Docket Item # 3
BAR CASE #2009-0049

BAR Meeting
May 20, 2009

ISSUE: Signage
APPLICANT: Jerald J. Littlefield
LOCATION: 428 South Washington Street
ZONE: CD / Commercial zone

Figure 2. Proposed signage in pediment.

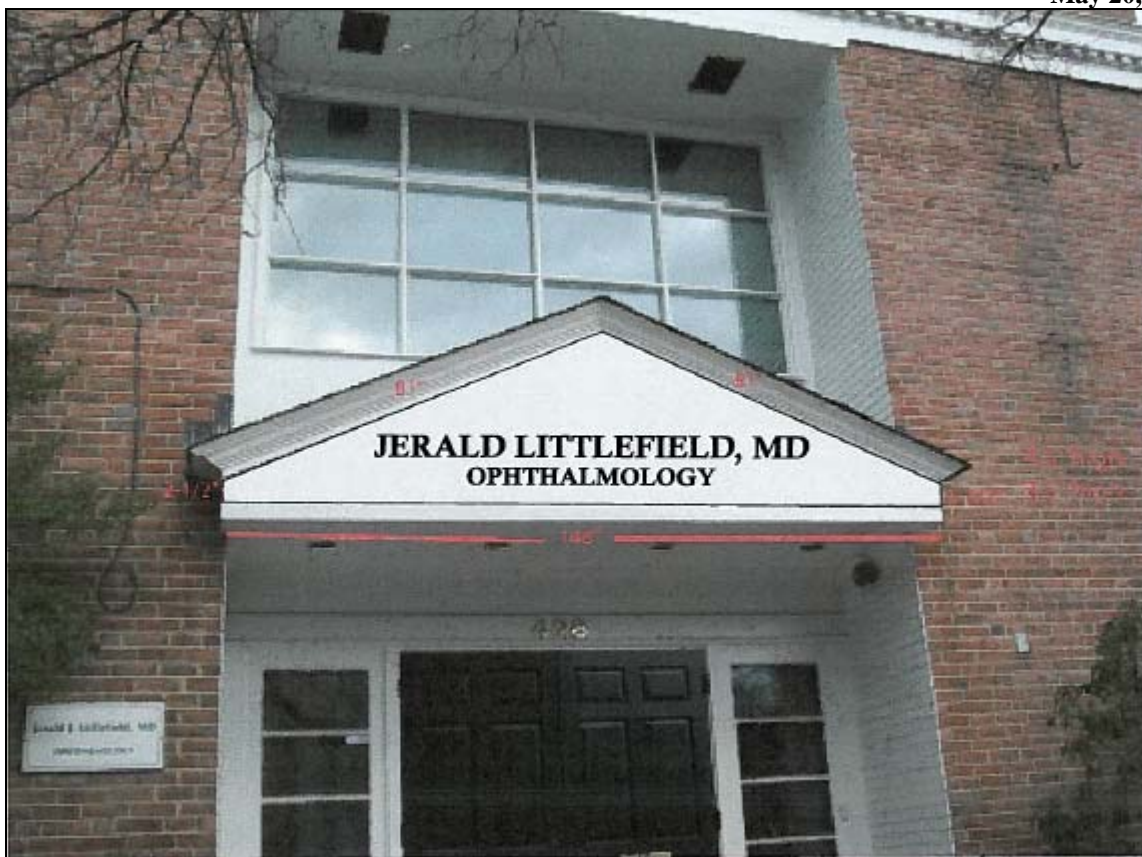
The applicant proposes to install individual letters mounted on the wood pediment over the entrance. The base of the pediment measures approximately 12 feet 4 inches. The black letters will be of formed plastic. The letters reading “JERALD LITTLEFIELD, MD” will be 4½ inches in height and the letters reading “OPHTHALMOLOGY” will be 3½ inches in height. The proposed signage will not be illuminated

In respect to the proposed signage, the *Design Guidelines* generally recommend one sign per business. The *Guidelines* also advise that “signs should not be attached to a building in a manner which requires the removal of historic materials” and “individual letter signs should be blind mounted on the front of a building.” Further, due to the building’s location on Washington Street, the proposed signage must also be compatible with the memorial nature of the Parkway. Staff finds that the proposed application for signage is consistent with the *Design Guidelines* and is appropriate for this location on the Parkway. However, Staff recommends that the letters be fabricated of metal rather than plastic and that the letters be blind-mounted. Staff has contacted the applicant who has agreed to the proposed recommendation.

C-1 Wall letters / signs must comply with USBC [H103-H111] Please indicate the method to be used for anchoring the letters to the wall.

IV: STAFF RECOMMENDATION: Staff recommends approval of the application for signage with the condition that the letters be metal rather than plastic and that they be blind-mounted.
